**CLEPA proposal for text for the new paragraph 4.9 to replace that as proposed in
TRANS/WP.29/GRSP/16/Rev. 2**

4.9 ISOFIX Marking

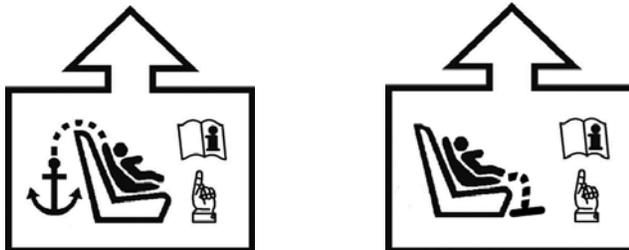
If the product includes ISOFIX attachments, the following information must be permanently visible to someone installing the restraint in a vehicle:

- The ISO ISOFIX logo followed by the letter(s) that is/are appropriate for the ISOFIX size class into which the product fits. As a minimum, a symbol consisting of a circle with a diameter of minimum 13 mm and containing a pictogram, the pictogram shall contrast with the background of the circle. The pictogram shall be clearly visible either by means of contrast colours or by adequate relief if it is moulded or embossed.
